**DATE:** SEPTEMBER 5, 2002  
**MODEL YEAR:** 1999 AND AFTER  
**VEHICLE MODEL:** UD1200/1400/1800CS  
**BULLETIN #:** EF - 16  
 FILE IN THE ENGINE SECTION OF THE TECHNICAL BULLETIN BINDER

## AISIN THROTTLE POSITION SENSOR WITH MOUNTING BRACKET

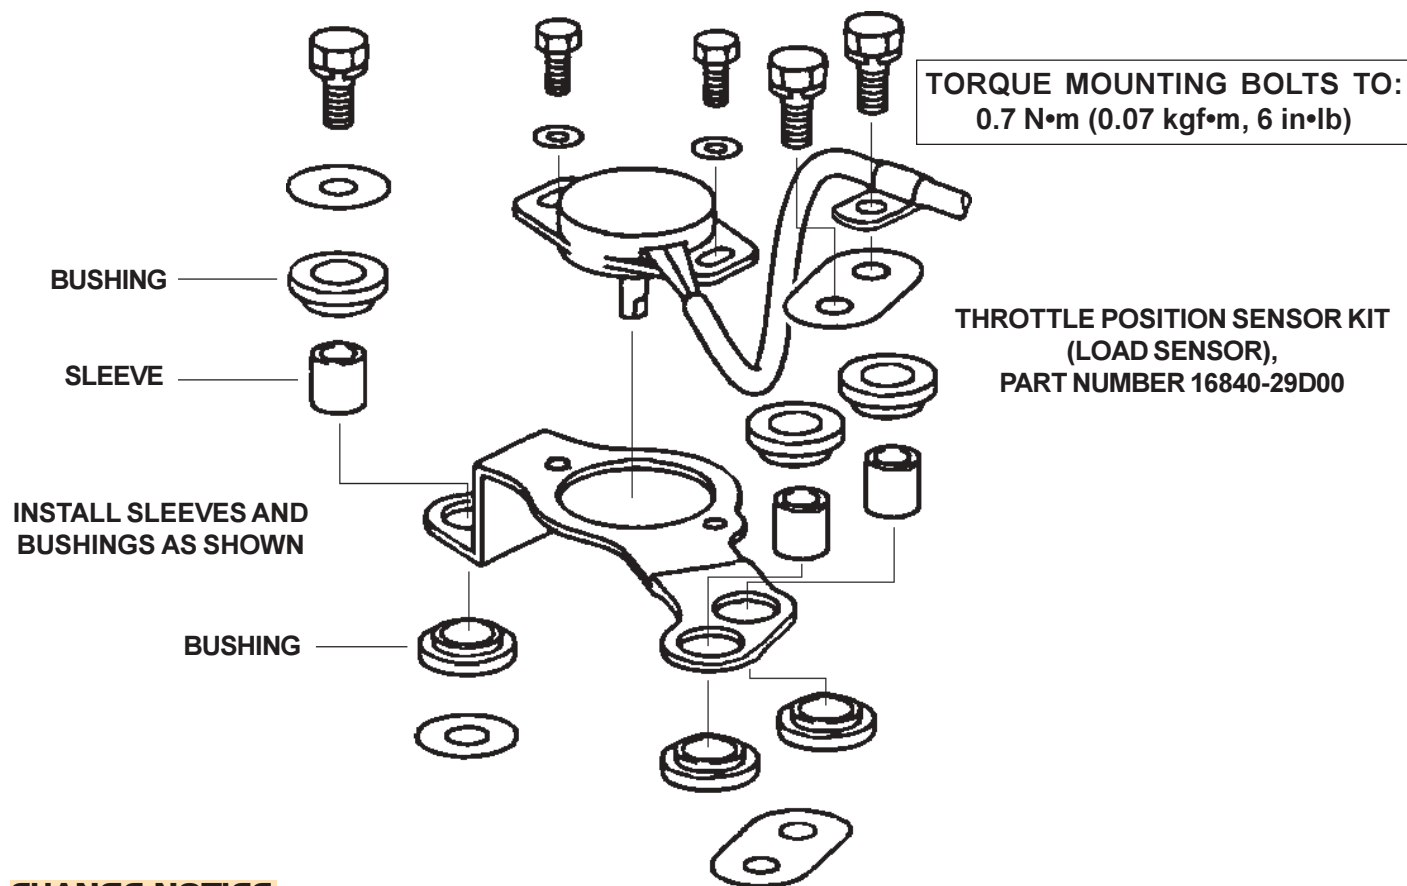
To advise UD Truck Dealer Service personnel that the existing throttle position sensor, part number 19138-29000, is no longer available. However, it is recommended for dealers to use their existing stock of this part before ordering the new throttle position sensor kit.

The revised throttle position sensor, kit part number 16840-29D00, includes a mounting bracket with bushings and sleeves as illustrated. Please refer to the recommended torque values for the attaching hardware.
